18 June 2025

Council Reference: COM/2024/317
Our Reference: 23-8110
Attention: Kyra Reid

RE: Response to Information Request – Material Change of Use for a Multiple Dwelling (73 Townhouses); Reconfiguring a Lot (Boundary Realignment and New Road); and Operational Works (Change to Ground Level and Vegetation Clearing) at 202 Baileys Mountain Road, Upper Coomera

Figure 1: Northern Elevation (Source: Red Door Architecture)

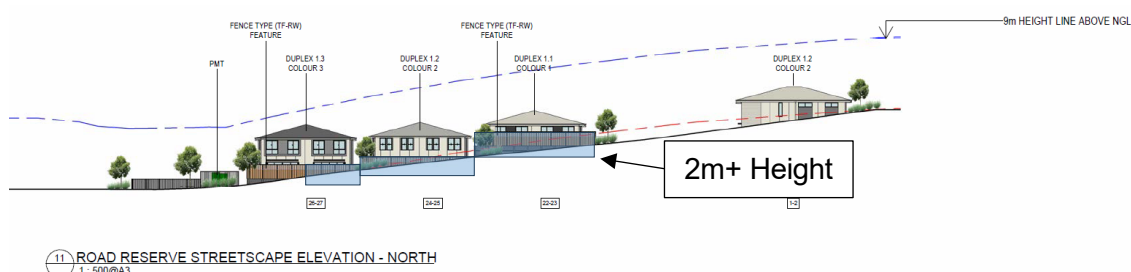
The extent of retaining wall and fencing height located along the new road reserve frontage (eastern boundary) which cumulatively exceeds 2m in height (when viewed internally) is limited to the rear of dwellings 22 to 26 – refer to **Figure 1** below.

An additional approximate width of 2.1m would be required to effectively provide the requested step in retaining, allowing for 2 x 300mm walls (excluding footings) and 1.5m of planter bed.

Figure 2: Section A – New Road Reserve Interface (Source: Red Door Architecture)

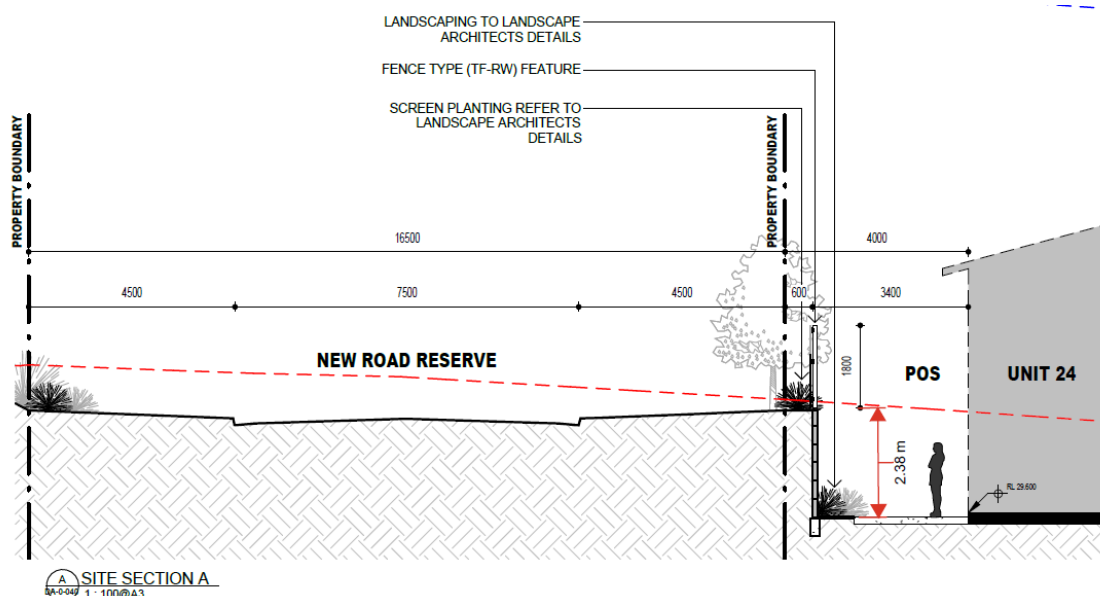
Figure 2 overleaf depicts the interface of the backyards of dwellings 22 to 26 with the retaining wall and fencing.

As demonstrated within **Figure 2**, a combined retaining wall and fence height of approximately 4.1m will exist toward the rear of the subject dwellings. This extent of retaining and fencing height is limited to 5 of the 73 dwellings located within the proposed development. This wall is retaining 'cut' and is therefore of no visual impact to road users, adjoining properties or any external observers.

Given the adverse impacts of reducing the private open space area or relocating the dwellings further to the east to accommodate the tiered retaining wall, the Applicant sought to explore opportunities to improve the current situation. The most effective mitigation measures that were identified include a reduction in the visual extent of the retaining and fencing located at the rear of the subject properties. These measures are listed below and have been incorporated into the Architectural Plan Package (**Attachment 2**):

Figure 3: Fence Type (TF-RW) (Source: Red Door Architecture)

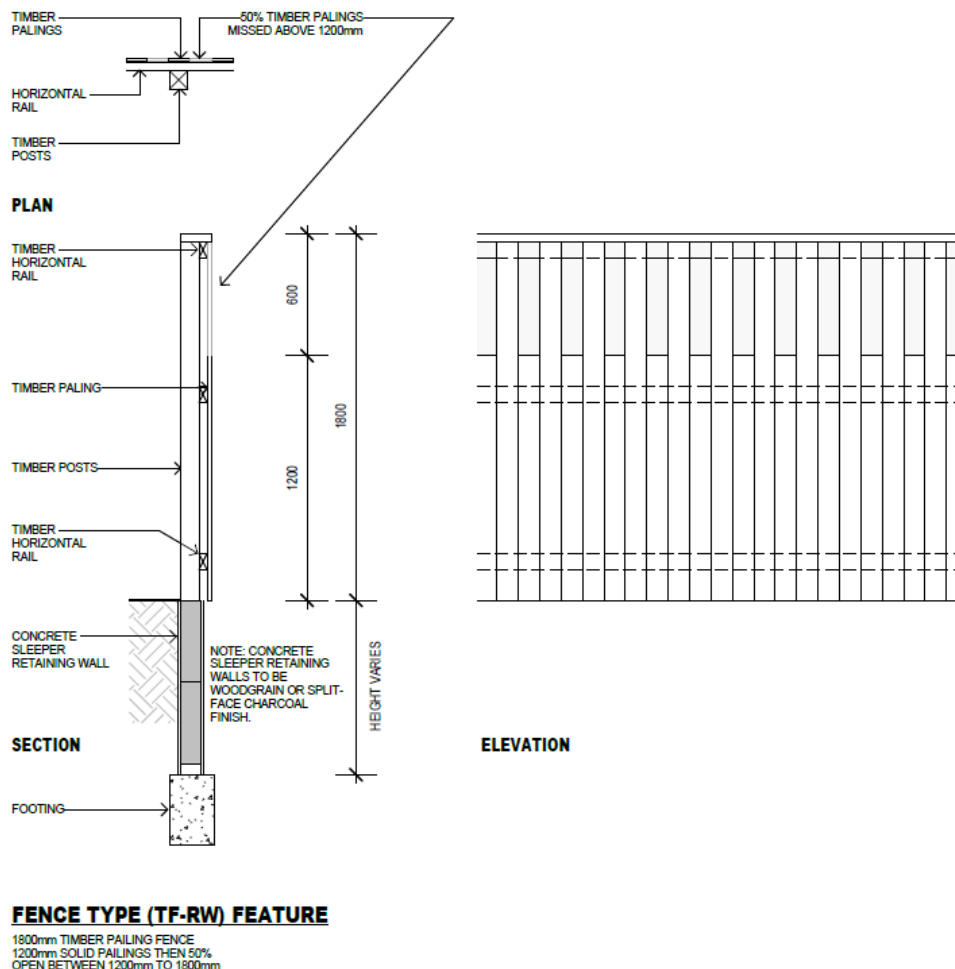
Figure 3 overleaf depicts the amended Fence Type (TF-RW) Feature which has been updated to include the 50% transparency component mentioned above.

- Landscaping at the base of the retaining wall to soften its appearance.
- 50% timber palings for the upper 600mm of the fence located atop the retaining wall to allow for greater transparency and therefore reduce the dominance of the cumulative height of the retaining and fencing.

Figure 5: Site Plan (Source: Red Door Architecture)

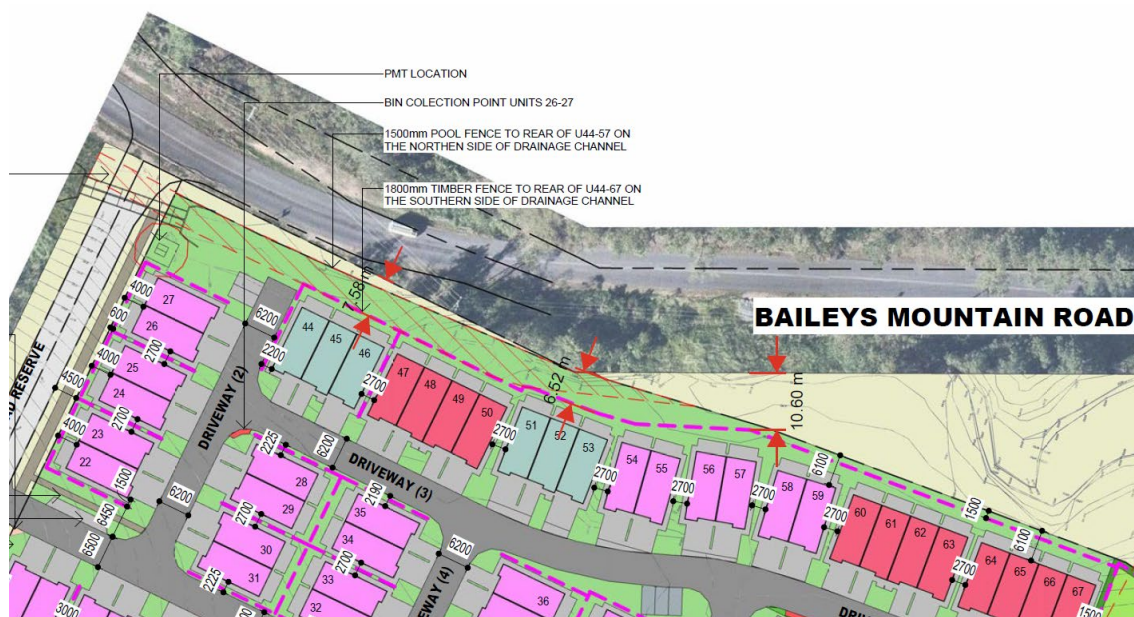
The extent of retaining wall and fencing height located along the Baileys Mountain Road frontage (northern boundary) which cumulatively exceeds 2m in height (when viewed externally) is generally limited to dwellings 46 to 57 – refer to **Figure 4** below.

As demonstrated within **Figure 5** above, the retaining wall and fencing is setback between 6.5m and 7.6m from the edge of the road reserve, providing a significant buffer will ultimately be softened by landscaping.

Figure 6: Section B – Baileys Mountain Road Interface (Source: Red Door Architecture)

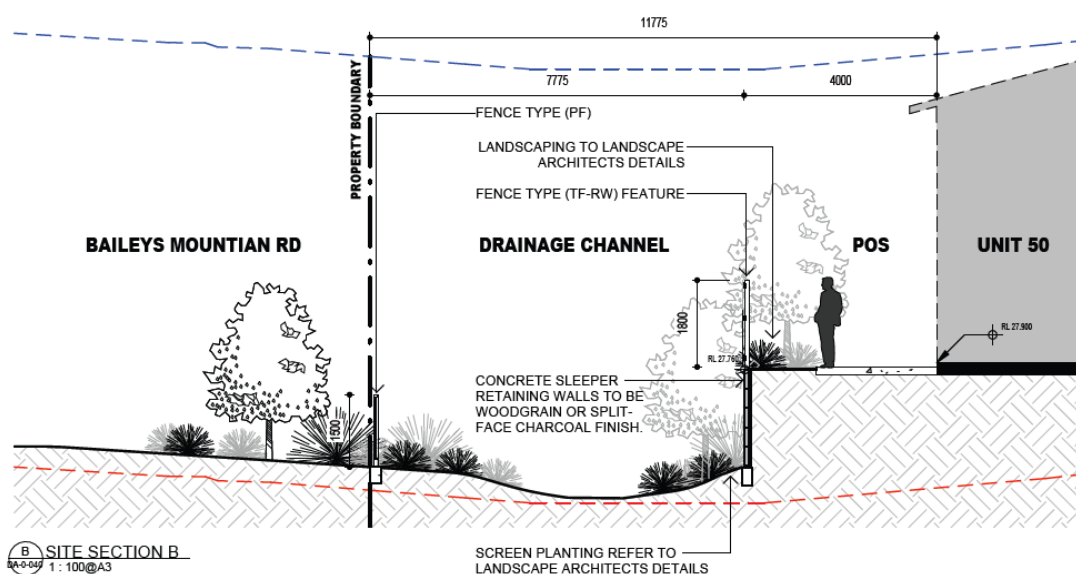
Figure 6 below depicts the retaining wall/fence in a section view and the corresponding buffer to the road reserve.

As demonstrated within **Figure 6** above, the proposed setback and landscaping outcome provides for an appropriate interface of the development with Baileys Mountain Road.

Figure 7: Building Height Exceedance Model (Source: Red Door Architecture)

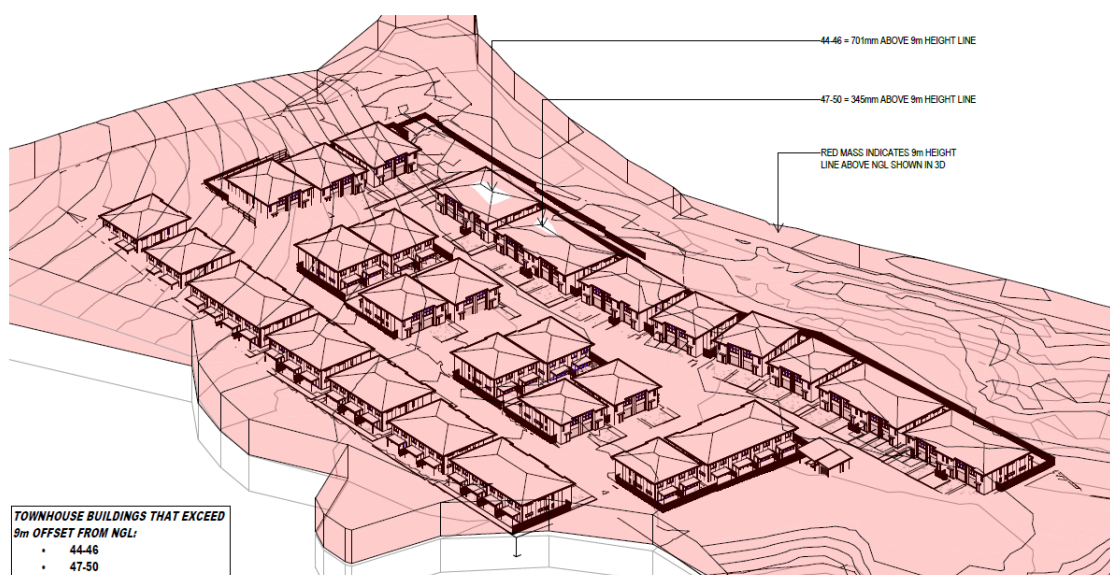
In response to Councils Action Notice, dated 8 November 2024, the applicant confirmed portions of the development exceed 9m in height above NGL. The applicant is requested to provide further assessment against the City Plan with regard to height. To ensure Officers are able to undertake a comprehensive assessment of the proposal, the applicant is requested to provide additional sections through the site (including through the proposed buildings).

As depicted within **Figure 7** below, the extent of the building height exceedance is relative to the pitch of the roofs for dwellings 47 – 50 and 44 – 46, which sit at a maximum height of 9.345m and 9.701m respectively.

Given the undulating nature of the subject site, the extent of the roofs which exceed 9m in height will be generally imperceptible to the public realm. To this end, it is acknowledged that the new road reserve (located along the northern boundary) sits at a finished level that is higher than the building pads of the development. However, direct sight lines to the subject dwellings will be screened by the row of dwellings adjoining same.
